Supplementary assessment report to Sydney Central City Planning Panel

Panel reference: 2016SYW072

Supplementary Report date	4 July 2018
Recommendation	Approval subject to conditions listed in attachment 3

Figure 1: Extract from the Landscape Concept Plan prepared by Canvas Landscape Architects, DA-L101, Revision A, dated 29 February 2016, showing the Stage 1 ground level communal open space area (right).

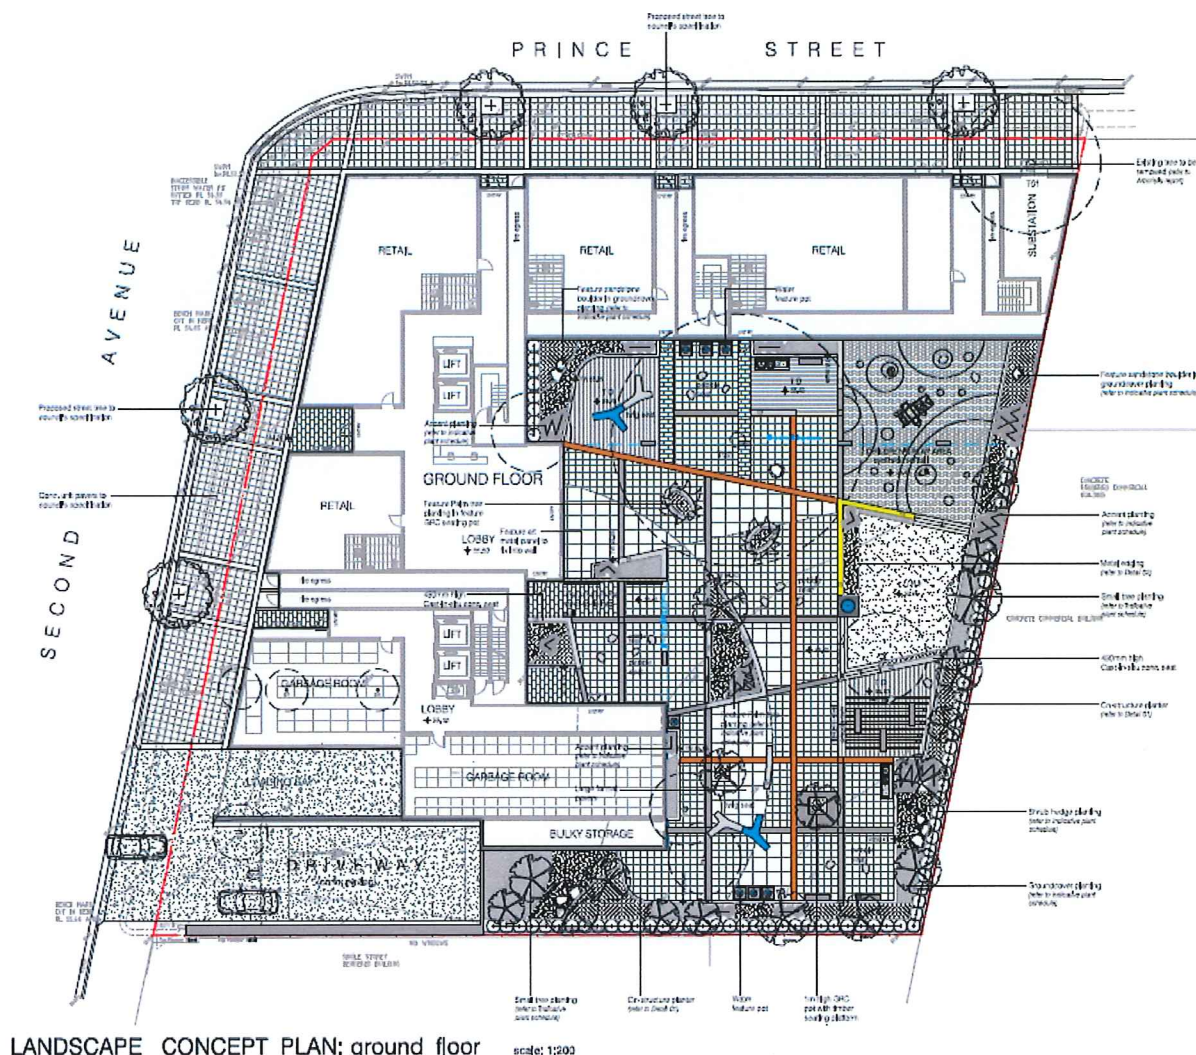
2. The Panel also requires submission of an additional plan which clearly shows the relationship between Stages 1 and 2, and specifically the shadowing impacts on the communal open space identified on plan DA-L101 29/2/16.

- 2.1 The Applicant's Solar Access diagrams at **attachment 1** demonstrate that all primary ground level, podium and rooftop communal open space (COS) areas receive direct sunlight, including the ground level COS area along the northern boundary of the site, as shown on Landscape Concept Plan DA-L101 and **Figure 1** below.

- 2.5 The shadow impact plans from the approved development at the adjoining site to the north (JRPP-16-03334 approved by the Sydney Planning Panel on 24 May 2018 for an 18 storey mixed use development at 10-14 Third Avenue, Blacktown) at **attachment 2** demonstrate that sufficient sunlight is available to the apartments and communal open space areas in mid-winter as required by the Apartment Design Guide. In particular, the rooftop COS areas achieve solar access at all times. The podium COS area for Stage 1 is in full sunlight from 11 am onwards. Parts of the ground level COS area for Stage 1 receives sunlight from midday onwards (being the area shown in Concept Landscape Plan DA-L101 and **Figure 1** above).
